Subregional RTEP Committee – Mid-Atlantic FirstEnergy (Penelec) Supplemental Projects

May 16, 2022

Penelec Projects Scope and Cost Changes

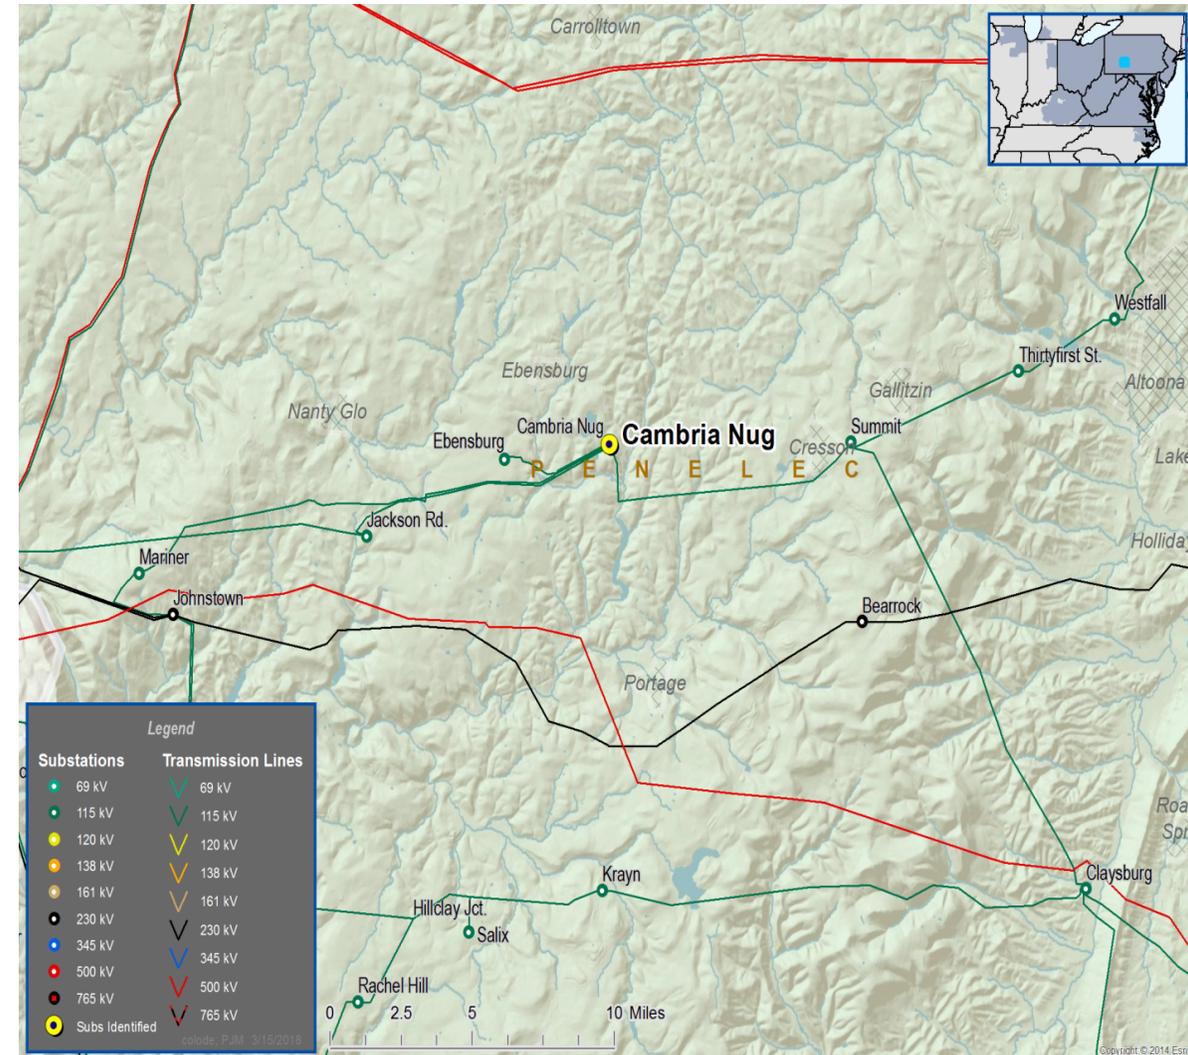
- Expand the existing Cambria Slope 115 kV Substation to a six (6) breaker ring bus. (\$1645)

Estimated Project Cost: \$30.0M

The change in project cost is primarily due to the expansion of the substation yard onto adjacent property. Construction of the new ring bus in the expanded yard would avoid the need for extended line outages during construction that would be needed if the ring bus were constructed within the existing station property. Additionally, material costs, including steel prices, have increased since the project was originally presented.

Erie South #6 230/115 kV Transformer Replacement

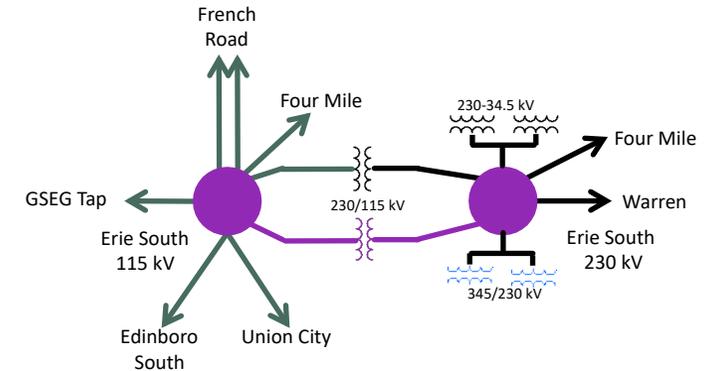
- Replace the #6 230/115 kV transformer with a 230/115 kV 180/240/300 MVA transformer.
- ~~Replace the 230 kV circuit switcher with a circuit breaker.~~
 - The 230 kV circuit switcher will not be replaced with a circuit breaker due to space constraints within the existing control enclosure for the relaying for a new circuit breaker.
